Application Number: 09/924,762

For: THE METHOD OF SERVO WRITING
FOR MAGNETIC RECORDING SYSTEM,
MAGNETIC RECORDING SYSTEM

LETTER TO DRAFTSPERSON

REPLACEMENT SHEET

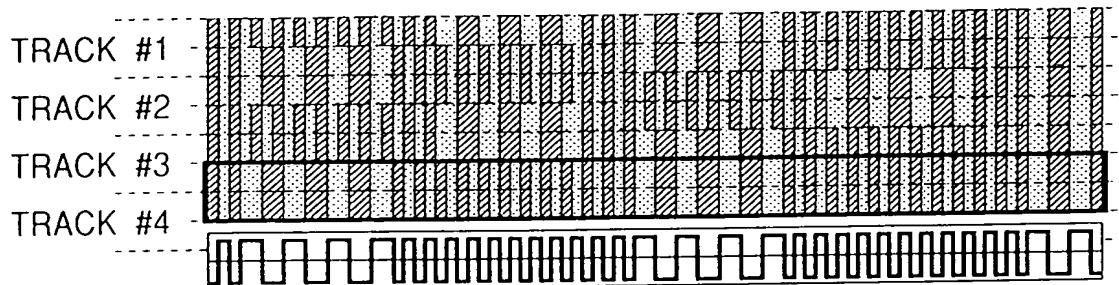
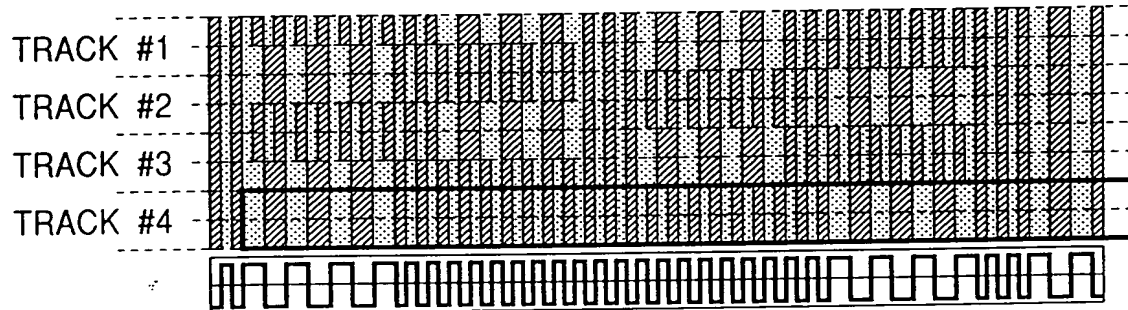
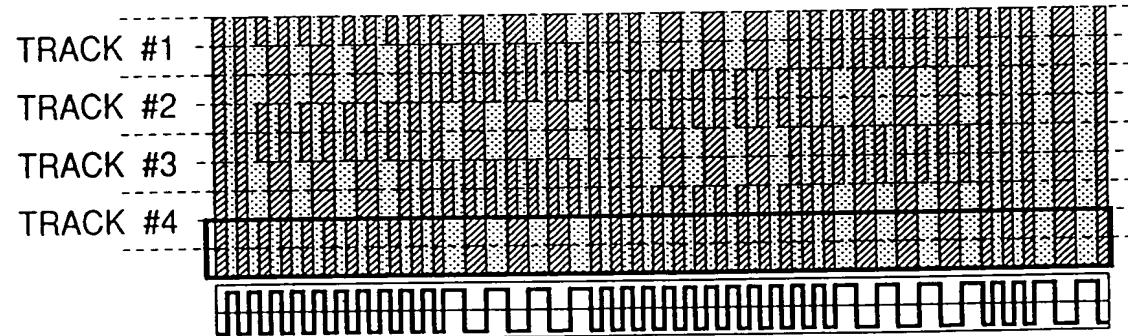
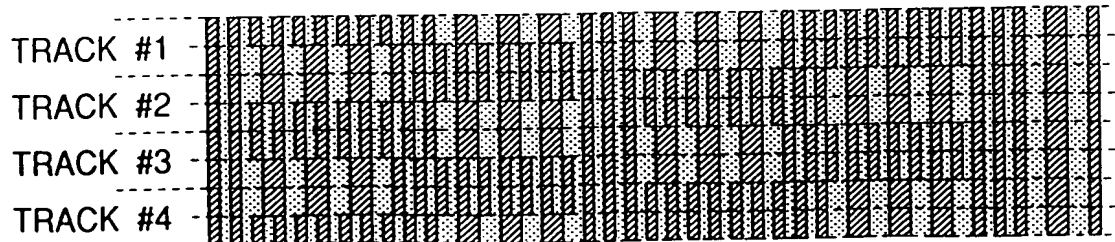
Please replace the drawings for Figures 4 and 18, with the views consecutively renumbered (a)-(d). A Letter to Draftsperson is also submitted herewith.

In response to the requirements set forth in the Notice of Draftperson's Patent Drawing Review enclosed with the Office Action mailed on December 10, 2003, Applicant is submitting replacement drawings for Figures 4 and 18. The views have been consecutively renumbered and are believed to be in compliance.
